**DOCUMENT 00 91 02  
ADDENDUM NO. 2**

PROJECT: 2024 Anthony, Hopper and Kahla MS Renovations

FROM: Carolina Weitzman, A.I.A.  
Natex Corporation Architects  
447 Heights Blvd, Houston, TX 77007

**E2.08**

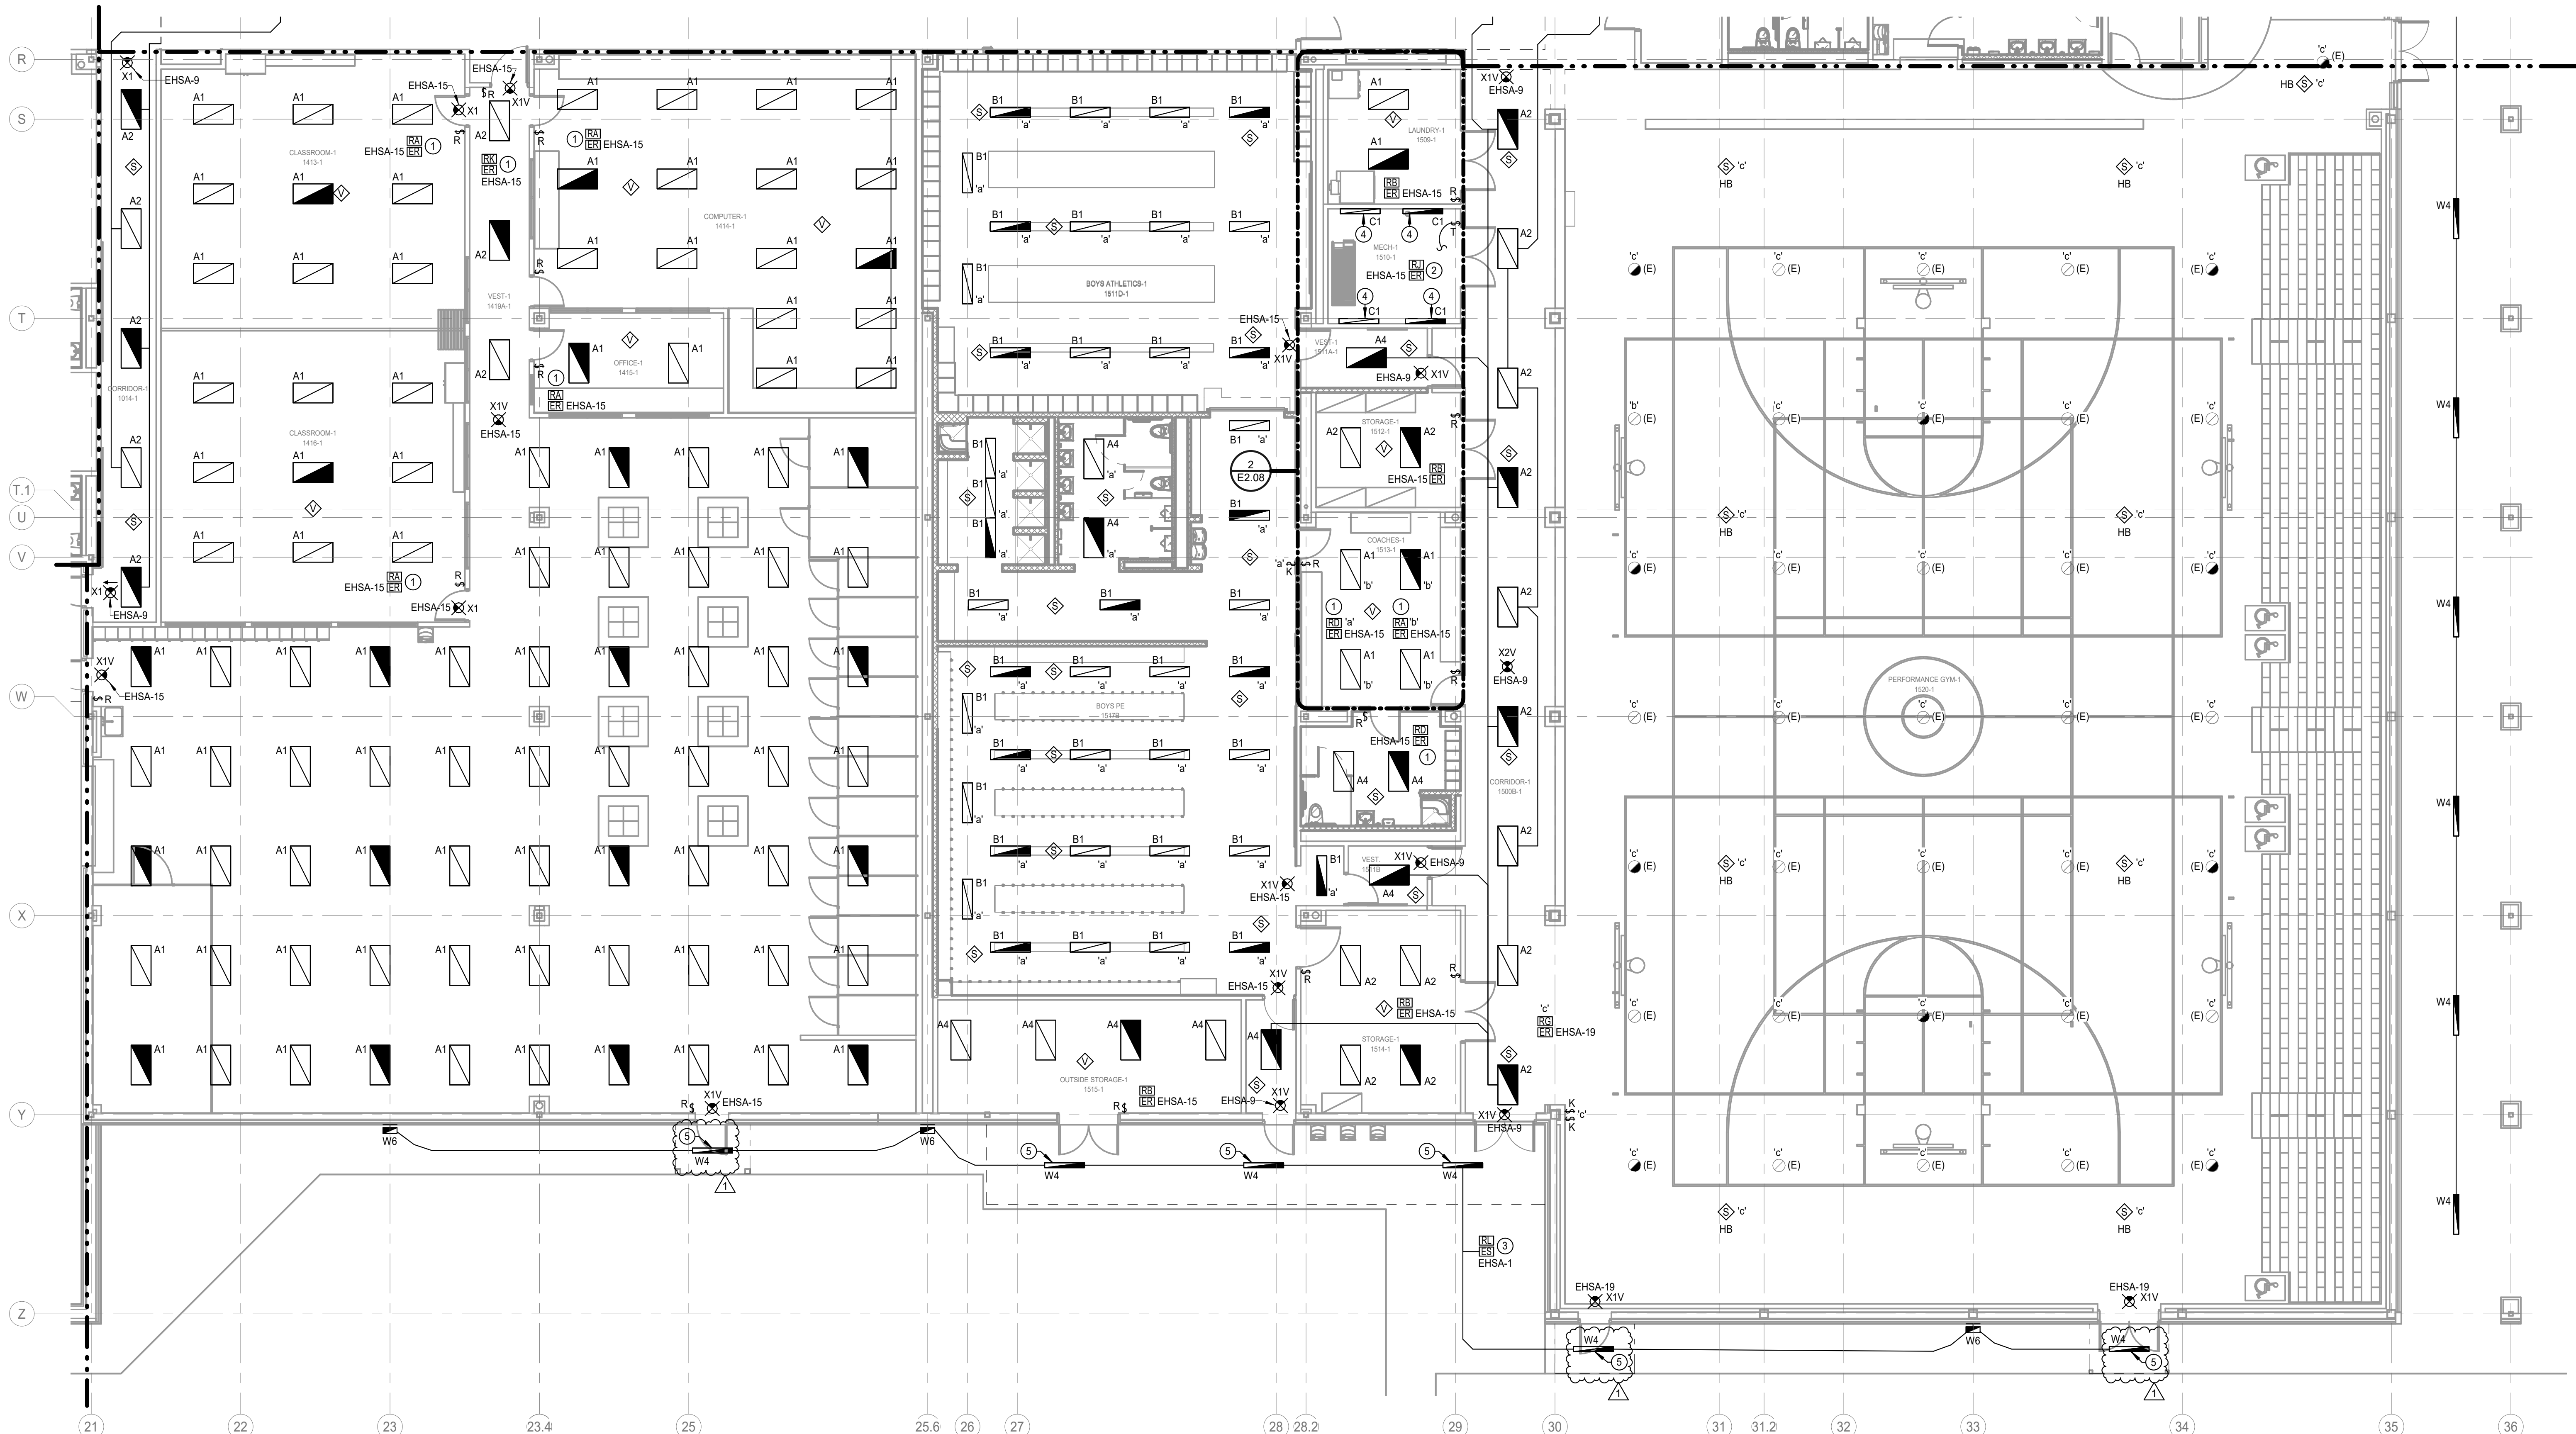
18. E2.04 ELECTRICAL LIGHTING 1ST FLOOR - AREA 'D'
  - a. Refer to revised sheet for new egress fixture.
19. E2.08 ELECTRICAL LIGHTING 1ST FLOOR - AREA 'G'

- a. Refer to revised sheet for new egress fixture.
20. E4.02 ELECTRICAL ONE LINE DIAGRAM
  - a. Delete the load bank circuit breaker and quick connects, accessories and control wiring related to the load bank circuit breaker shut trip. Refer to revised sheet.

Project Number: 22084  
 Date: 29 DECEMBER 2024  
 Drawn by: NY  
**TECHNOLOGY**  
 DEMOLITION FIRST  
 FLOOR PLAN - AREA 'C'  
**T0.03**

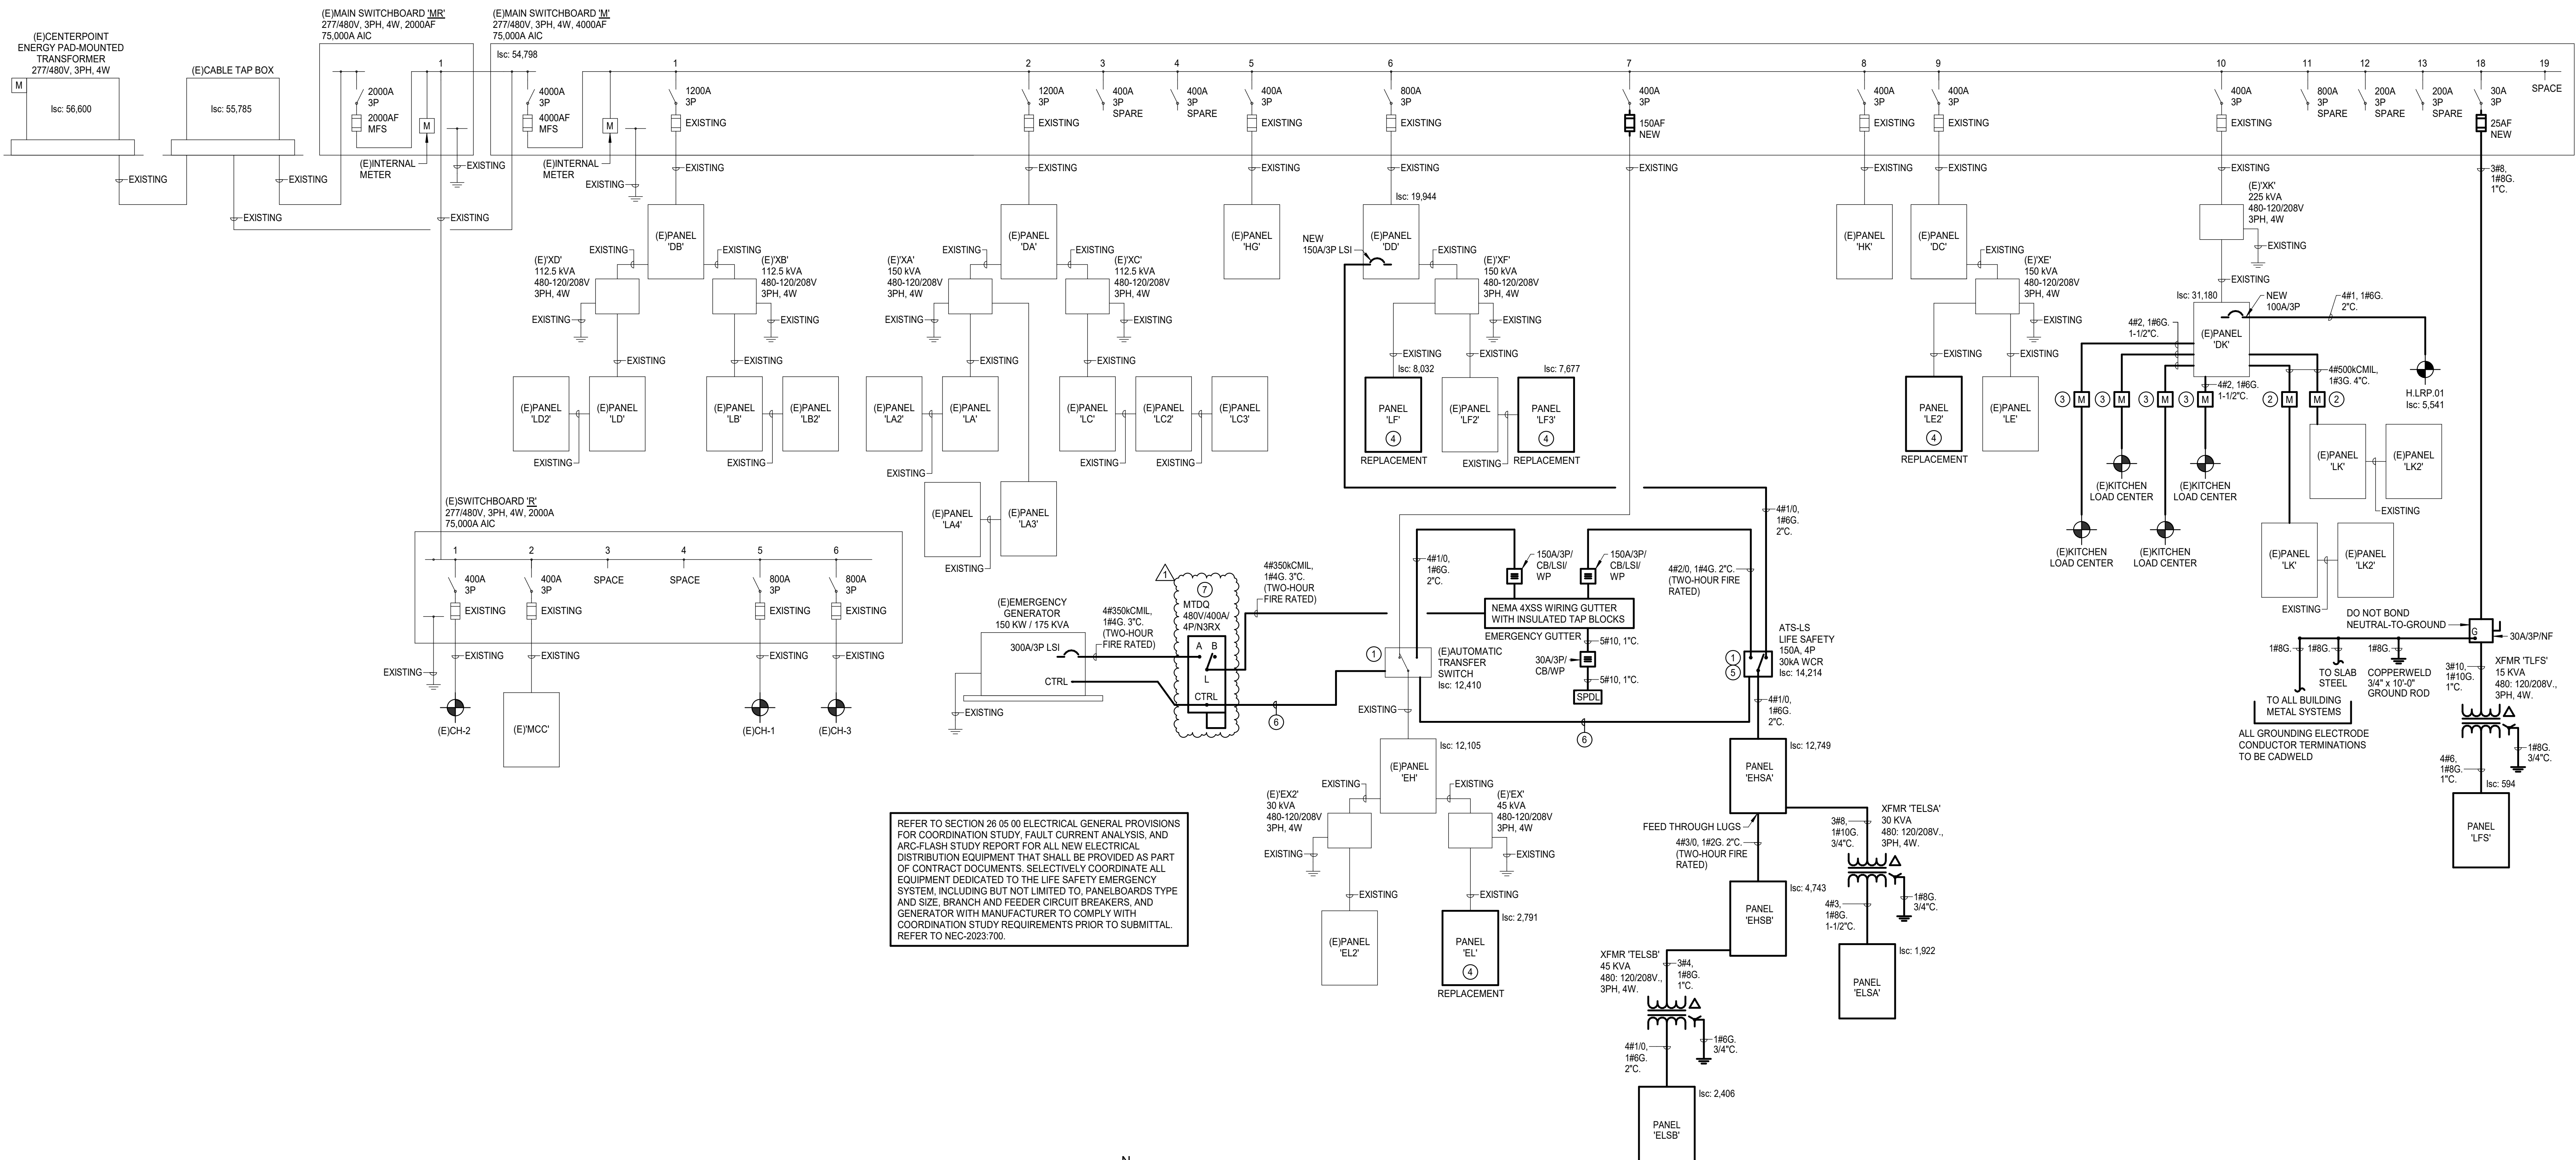
- a. Card reader now to be demolished.
22. T0.07 - TECHNOLOGY DEMOLITION FIRST FLOOR PLAN - AREA G
  - a. Add Demo subscript 'D' to AV rack in Elec-2, 1505A-2.

**T1.03**

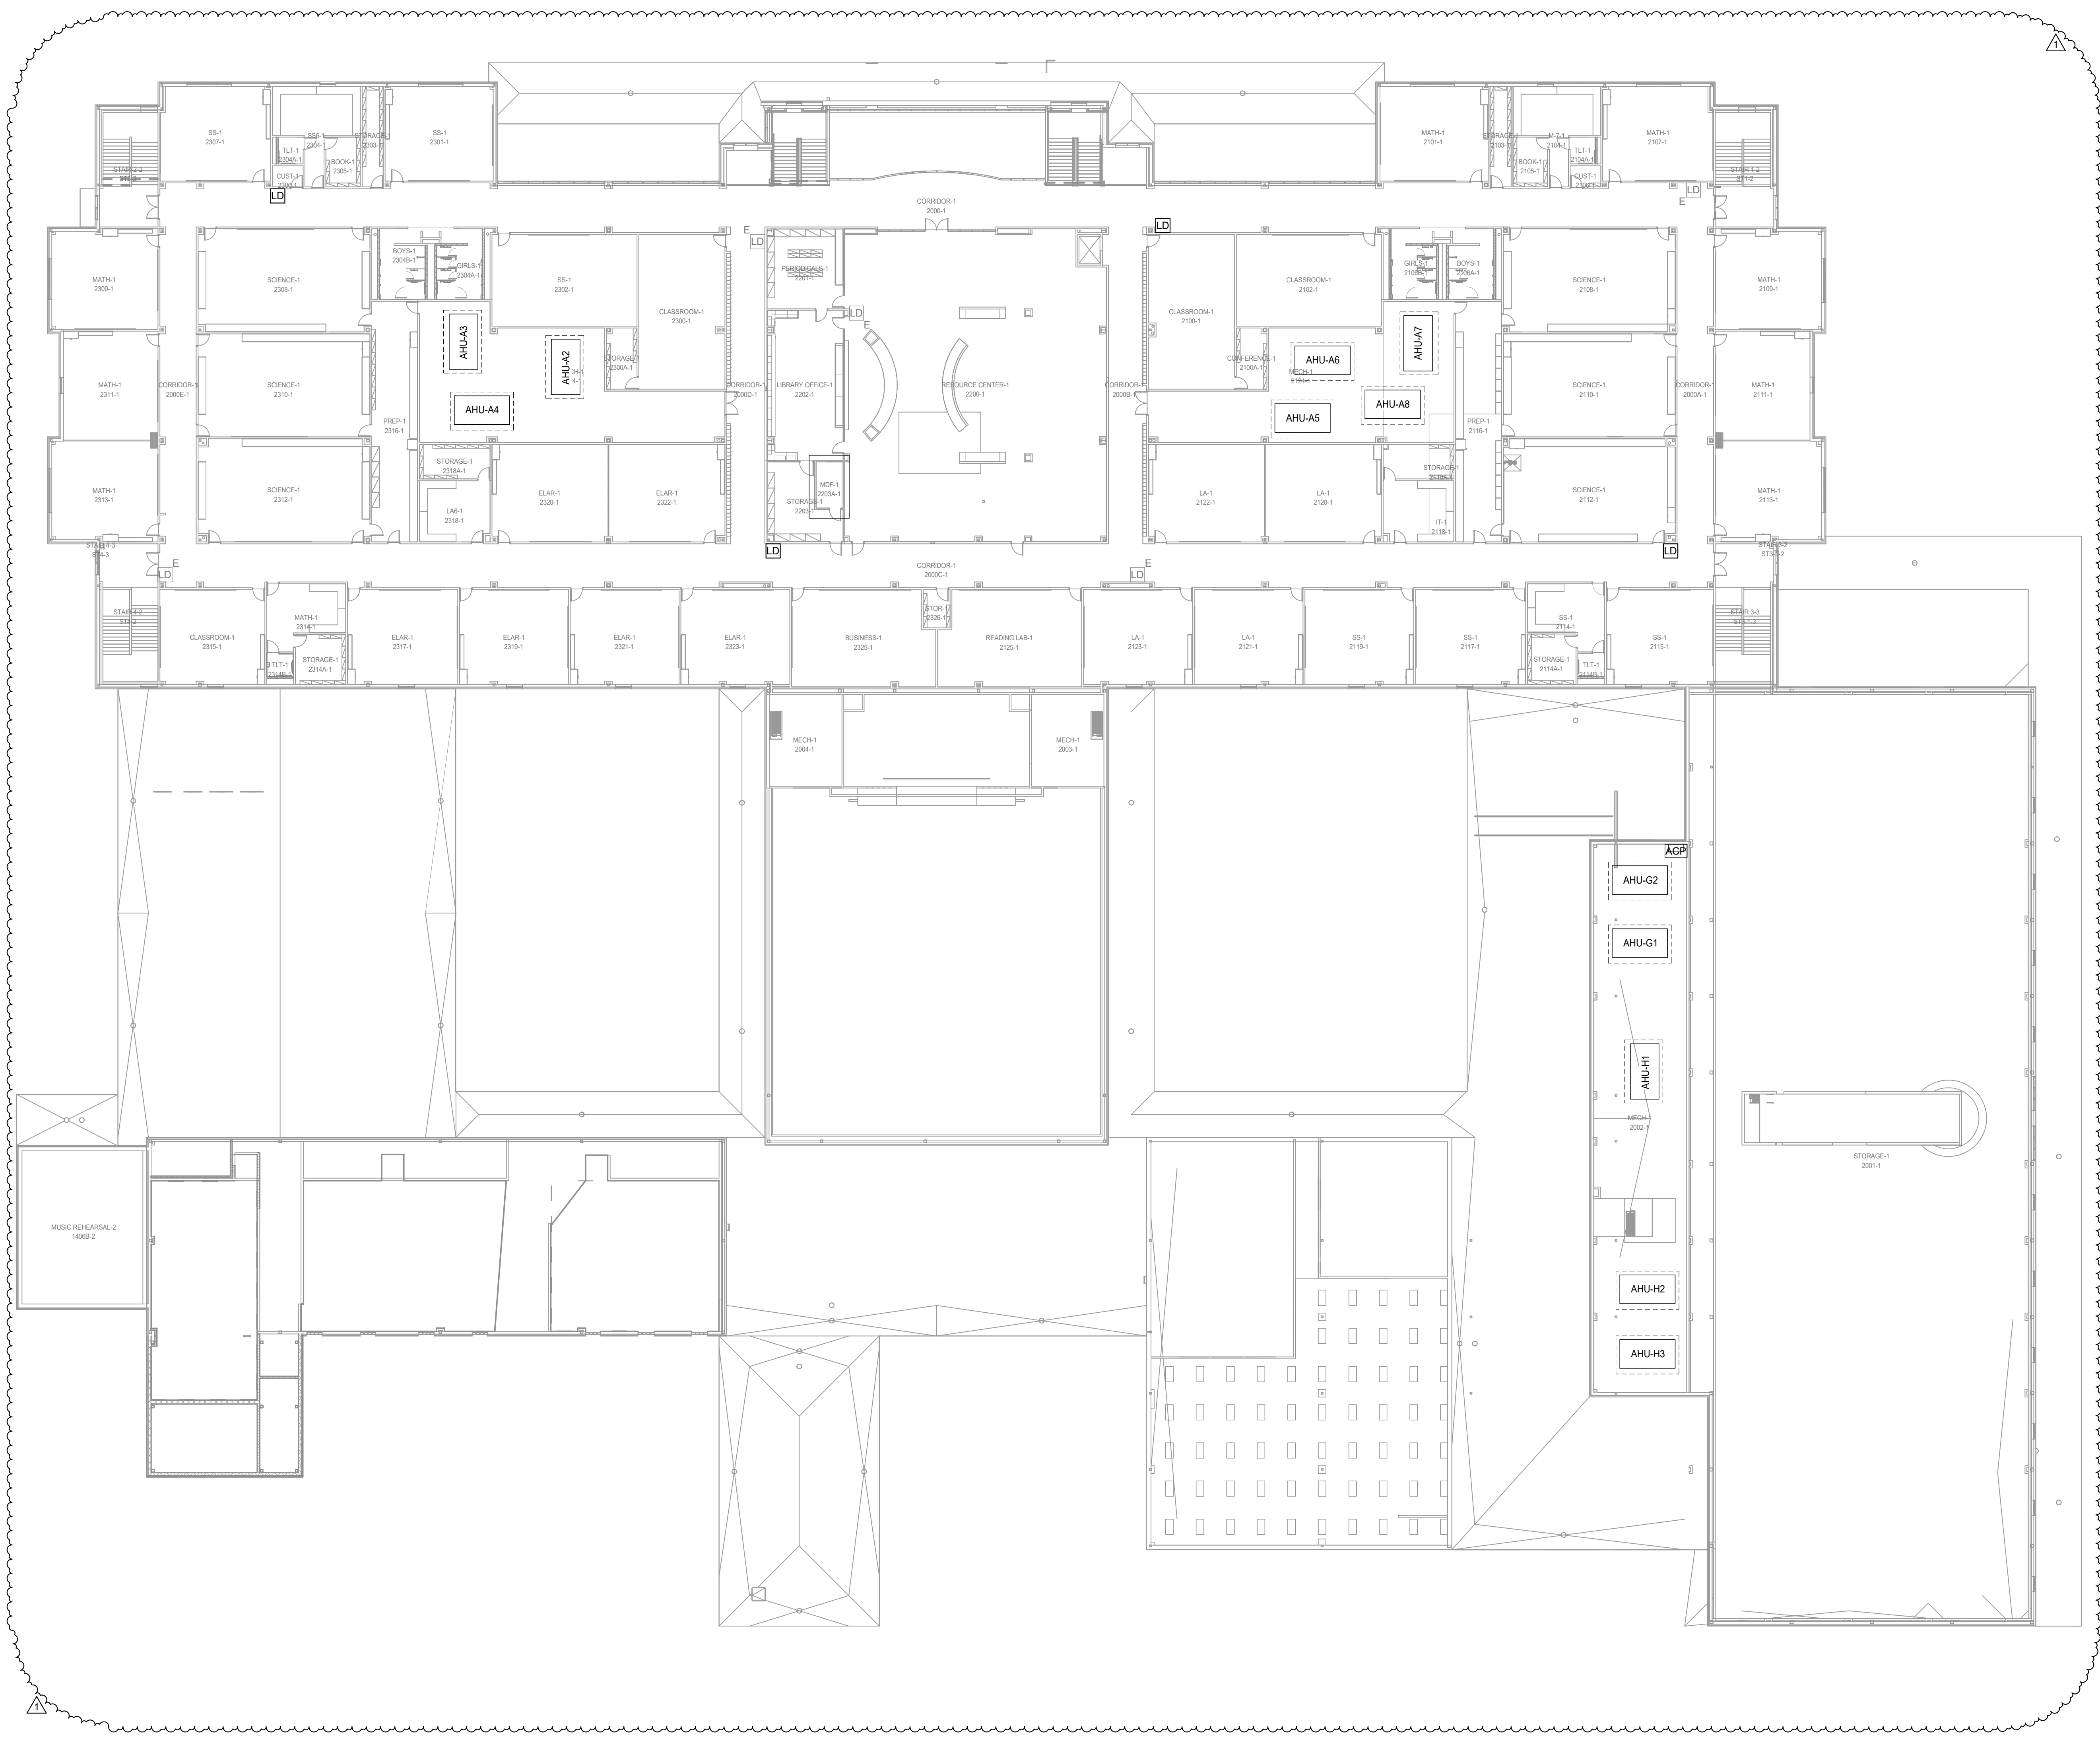
24. T1.02 - TECHNOLOGY SITE PLAN – NEW
  - a. Add Camera and Intercom speaker height.
25. T1.03 - TECHNOLOGY COMPOSITE FIRST FLOOR PLAN
  - a. Remove sleeves from the plan.
